USB 3.0 Hub Controller

(Ver 2.0)

This document describes the notification of μPD720211, USB 3.0 Hub controller.

20140307-1. Recommend applying FW for products supporting gang mode without a power switch

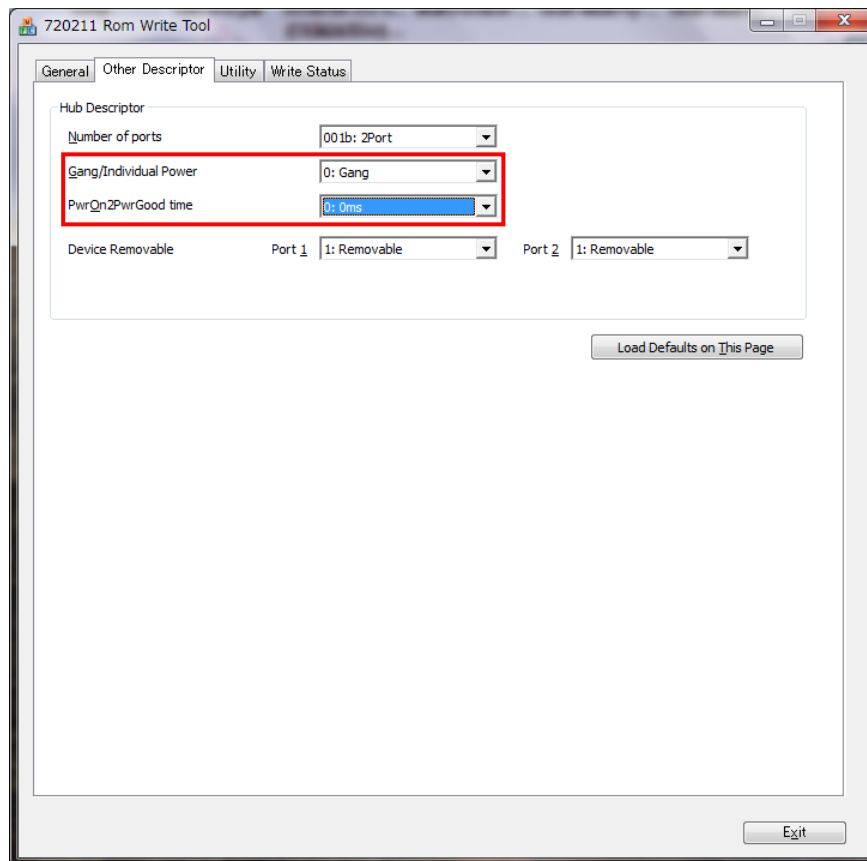
[Problem]

Some non-compliant USB 3.0 devices that are connected to uPD720211 cause the interoperability problem that they are not recognized by the PC after hibernation and resume when uPD720211 is used in the gang mode and VBUS on its downstream port is not controlled by a power switch. Those devices seem to have the restriction that they go out of control when detecting the disconnection of the far-end Rx termination while keeping VBUS.

The external serial rom is needed to solve this problem although it is optional on uPD720211.

1. This problem is fixed by applying FW. Please apply FW Version 3.0.0.1 - 001 or later when the product supports the gang mode without power switch. Note that this workaround is enabled only when Gang/Individual Power is "0: Gang" and PwrOn2PwrGood time is "0: 0ms" in the uPD720211 ROM Writing Tool for Windows. And when this workaround is enabled, "Low Power Mode during Suspend" is forcibly disabled and power consumption is higher than when this workaround is disabled due to enabling the Rx termination.

2. Or, use a power switch in gang mode. In this case, PwrOn2Pwrgood time should be "1: 100ms" in the uPD720211 ROM Writing Tool and using this workaround has no effect on power consumption.
